Public Comment No. 1642-NFPA 70-2024 [Global Input]

This Global Public Comment is for CMP-2 to review the use of the terms “overcurrent”, “overcurrent protective devices” and “overcurrent protection”.

Committee Statement

Figure Informational Note 120.1 Branch-Circuit, Feeder, and Service Load Calculation Methods.

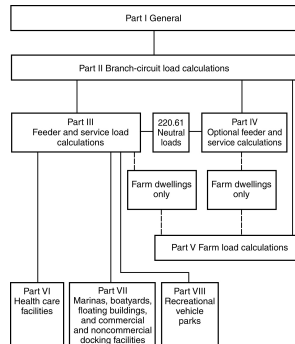
The Correlating Committee directs CMP 2 to revise the scope as it relates to the addition of Article 220, Part VIII, Recreational Vehicle Parks. Additionally the phrase "commercial and noncommercial" needs to be revised in the scope and informational note figure for correlation with the title of Article 555.

Statement: The Scope of Article 120 and Figure 120.1 are revised to reflect the correct title for Part VII and the addition of Part VIII.

Figure 210.52(C)(1) Determination of Area Behind a Range, Counter-Mounted Cooking Unit, or Sink.

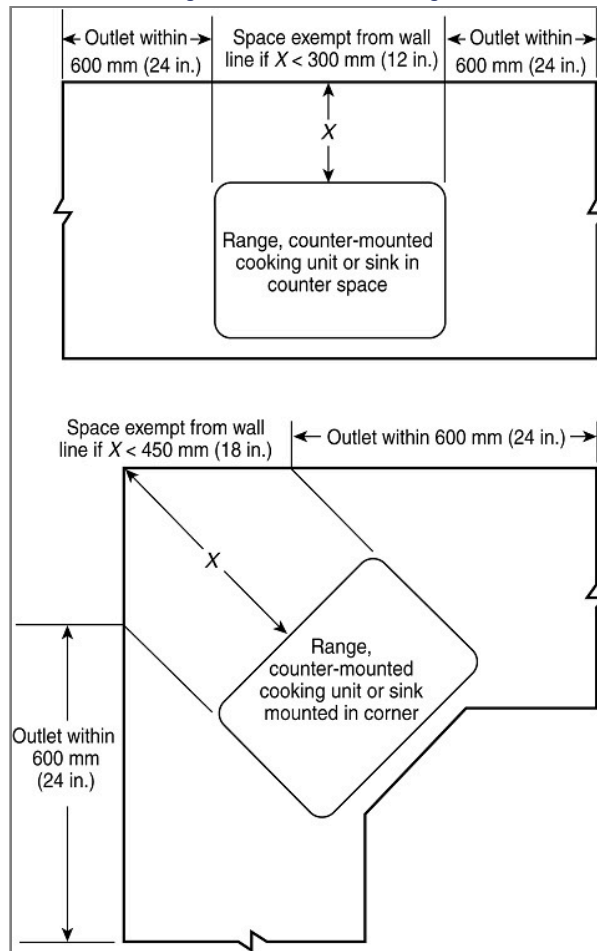
Exception No. 1: Receptacle outlets shall not be ~~required~~ allowed directly behind a range, counter-mounted cooking unit, or sink in the installation described in Figure 210.52(C)(1).

Figure D.15(a) Monitoring Controlled and Noncontrolled Loads, 50 Amperes EVSE Example Total Circuit Load Managed by a PCS .

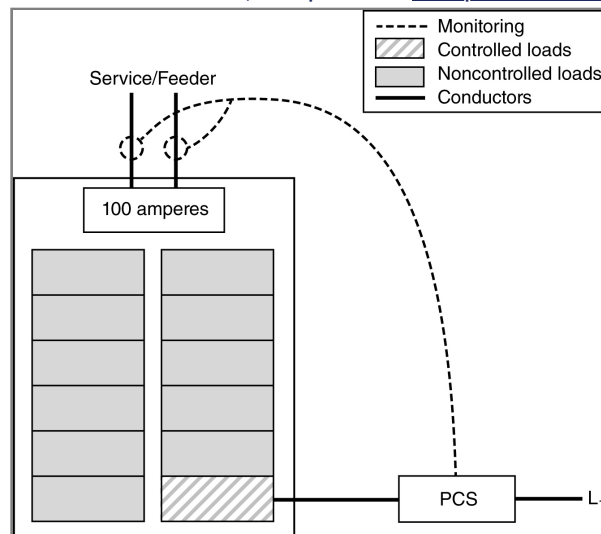
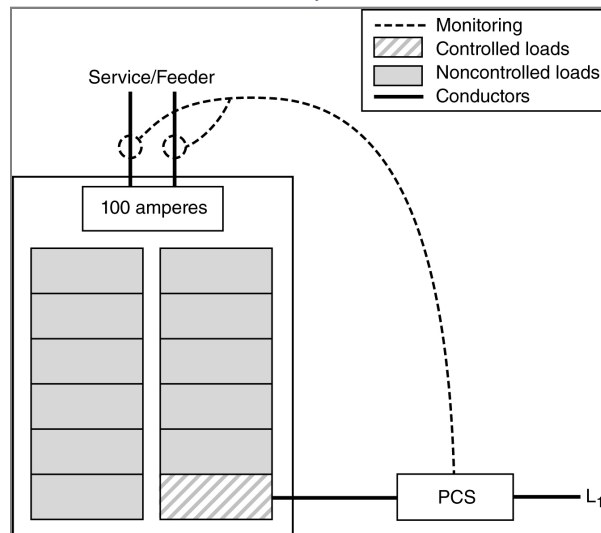
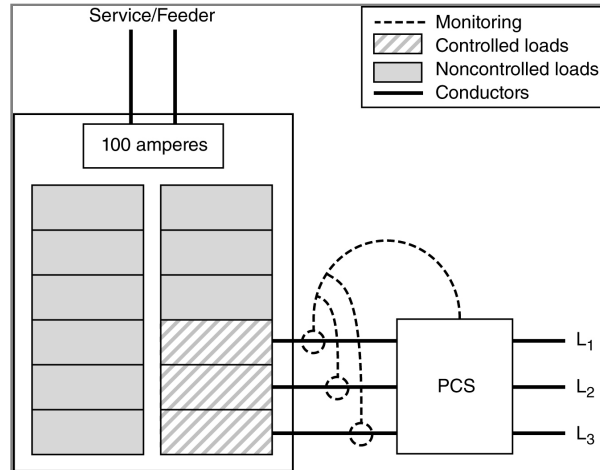
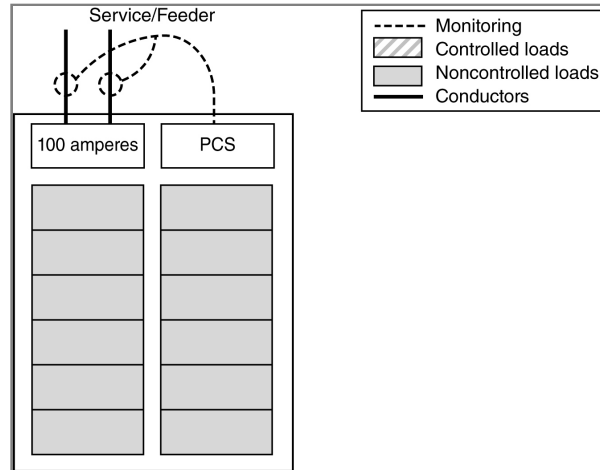
~~Total~~ Since the PCS control setpoint is greater than the total connected noncontrolled load, the total service load is noncontrolled plus controlled loads = 17,040 - 200 volt-amperes (71 amperes 80 amperes , 240 volts)

Figure D.15(D) was corrected to show that the PCS is monitoring only controlled loads.

Figure D.15(d) Monitoring Only Controlled Loads, All Loads Controlled.

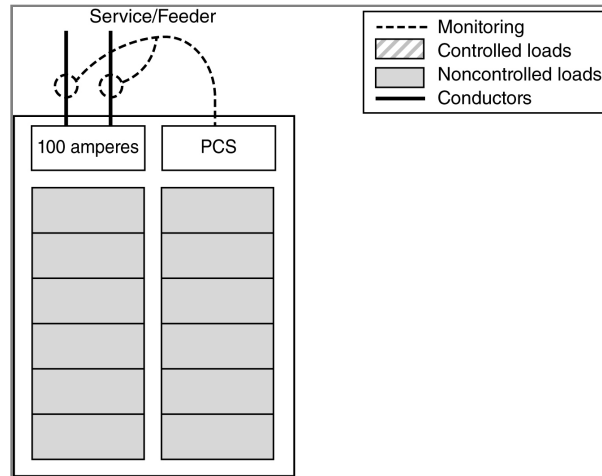
Figure D.15(d) appears to be incorrect, in that the figure shows all branch circuits as Noncontrolled Loads (solid grey), while the example text clearly states that the PCS monitors only controlled loads, which means all branch circuits should be revised to use the diagonal grey and white coloring.

Figure D.15(D) was corrected to show that the PCS is monitoring only controlled loads.
